Service Bulletin

SUBJECT: Special Coverage Adjustment – Electric Power Steering Assist

**MODELS: 2006-2009 Chevrolet HHR (non-turbo)
2003 Saturn ION
Equipped with Electric Power Steering**

Subject: 14119 – Special Coverage Adjustment
Electric Power Steering Assist

SERVICE PROCEDURE**Power Steering Assist Motor Housing Inspection -- All Vehicles Except Chevrolet HHR**

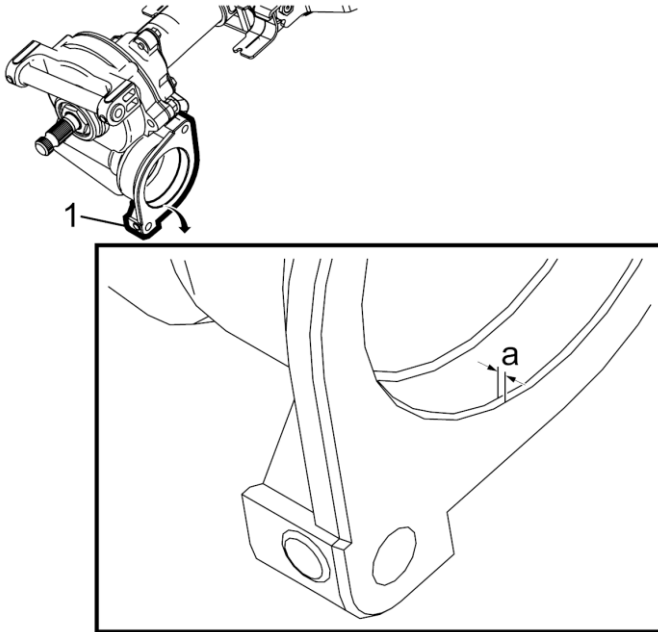
Caution: Do not install a seal on a "first design" steering motor. Installing a seal on a "first design" steering motor may damage the steering motor which may result in loss of assist steering. A seal is only required on a "second design" steering motor – the motor with the larger chamfer.

Before installing the power steering assist motor, inspect the power steering assist motor housing (1) to verify the steering column design:

- *First Design:* If the chamfer (a) is **1 mm (0.04 in)** and **30 degrees** then the steering column is the first design and a power steering assist motor O-ring seal is **NOT** needed.
- *Second Design:* If the chamfer (a) is **2.7 mm (0.11 in)** and **45 degrees** then the steering column is the second design and a **NEW** power steering assist motor O-ring seal **IS** needed.

1. Remove the power steering assist motor. Refer to *Power Steering Assist Motor Replacement* in SI.
2. Install the new power steering assist motor. Refer to *Power Steering Assist Motor Replacement* in SI.
